# Access Compliance Report

## Public Rights-of-Way

### (Pedestrian Signals)

Intersection ID: N/A	Main Street:	Cross Street: N/A	Location: N/A
ADA ID: 108A4BA55496	Signal Type: One Push Button-Non APS	Overall Compliance: No	Severity Score: BTN 1: N/A BTN 2: N/A No BTN: N/A
Codes/Mitigation Info/Possible Solution		Field Measurements/Component Compliance

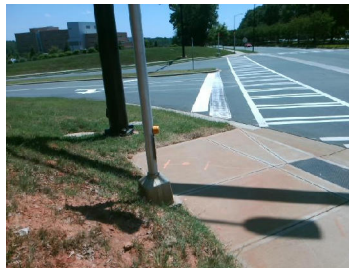
Surveyor Notes: TEXT HT 1/2

PROW/ADA: R410.6, TMUTCD 4e.08, R406.2

Possible Solutions: Replace Signal Push Button With APS Button on New Post. Remove & Replace Sign.
